No. 2241, Rev. I
ATA Code 32-20
Recurring Inspection

SUBJECT: LANDING GEAR - INSPECTION/REPLACEMENT OF NOSE LANDING GEAR FORK

**SYNOPSIS OF
CHANGE:**

EXISTING FORK INSPECTION
Figure 1

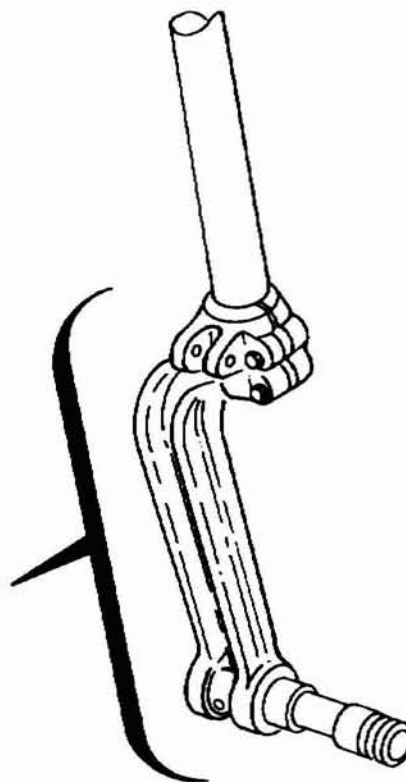
1. Visually inspect the nose landing gear fork for cracks. Pay special attention to the forward and aft upper surfaces of the lower "I" section flange, at the transition radius where the flange blends into the piston socket boss. See Figure 1.
2. Perform a fluorescent penetrant inspection as follows:

LAMINATED SHIM INSTALLATION
Figure 2

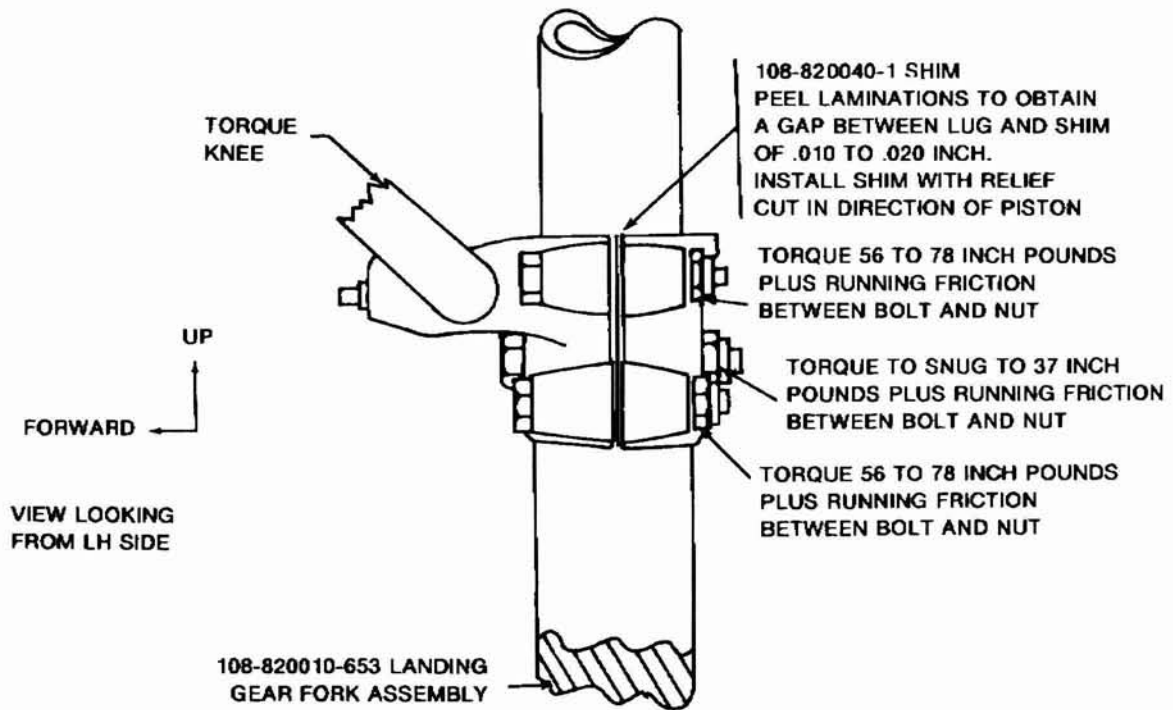
Corrected gap measurement and illustration orientation of Figure 2; added SPARES AFFECTED statement.

5. If cracks are discovered in the nose landing gear fork and axle assembly, replace the fork with a new P/N 108-820010-653 landing gear fork in accordance with the Maintenance Manual.

Use Figure 2 in conjunction with the existing Maintenance Manual procedures.
